[Docket No. 2003-SW-06-AD; Amendment 39-13064; AD 2003-04-15]

Airworthiness Directives; Sikorsky Aircraft Corporation Model S-76A, B, and C Helicopters

ACTION: Final rule; request for comments.

**RBD INSPECTION LIMITS
FIGURE 1.**

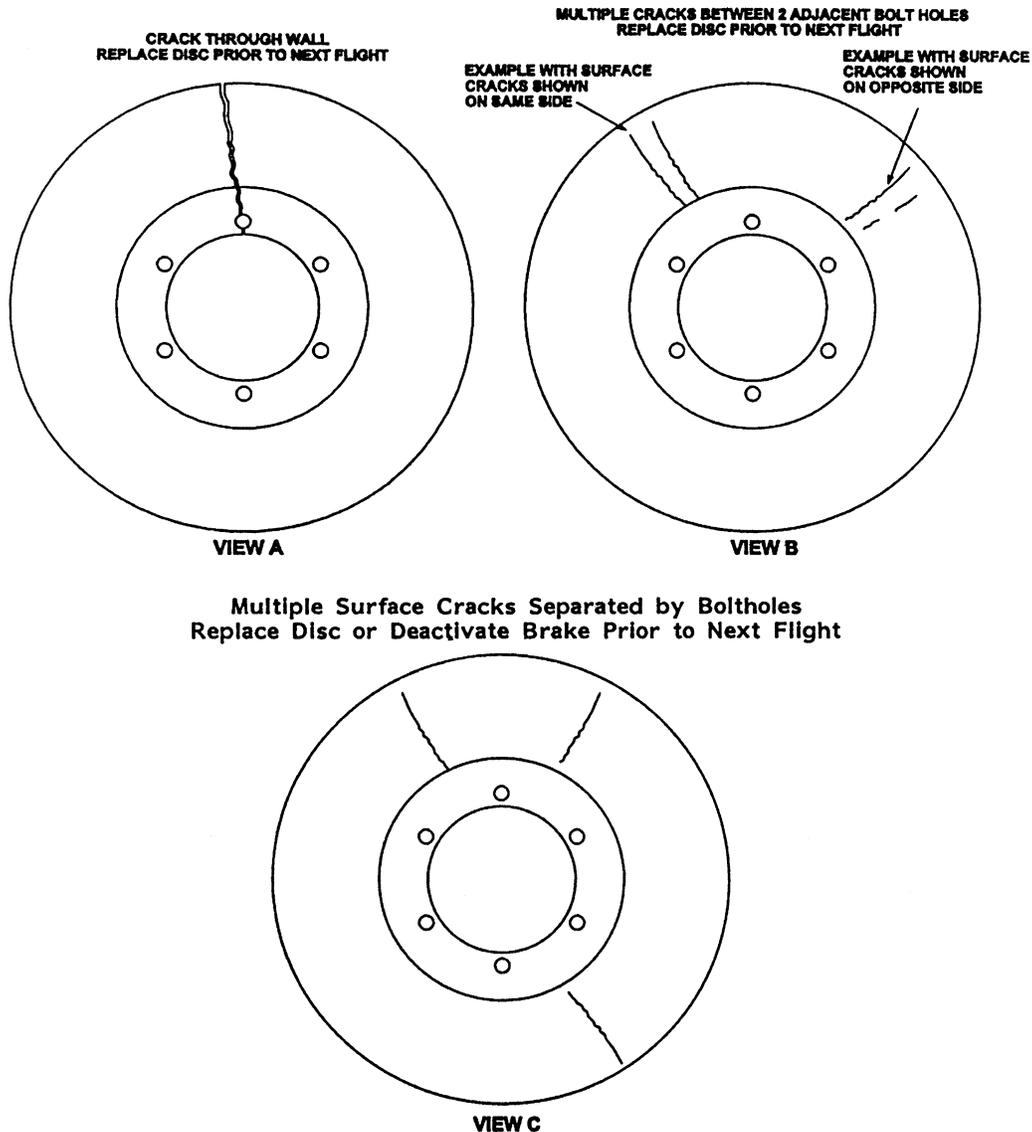
(b) Before the first flight of the next day following any day in which the RBD was used, visually inspect each RBD, P/N 76363-09103-104, for a crack, and perform the following actions. See Figure 1.

(1) If you find a crack through the entire RBD thickness as shown in Figure 1, View A, replace the RBD with an airworthy RBD, other than P/N 76363-09103-104, before further flight.

(2) If you find two or more surface cracks between adjacent boltholes as shown in Figure 1, View B, replace the RBD with an airworthy RBD, other than P/N 76363-09103-104, before further flight.

(3) If you find a surface crack or surface cracks separated by the boltholes as shown in Figure 1, View C, replace the RBD with an airworthy RBD, other than P/N 76363-09103-104, or deactivate the RBD before further flight.

Note 3: Short "glazing" cracks are not a cause for rejection.
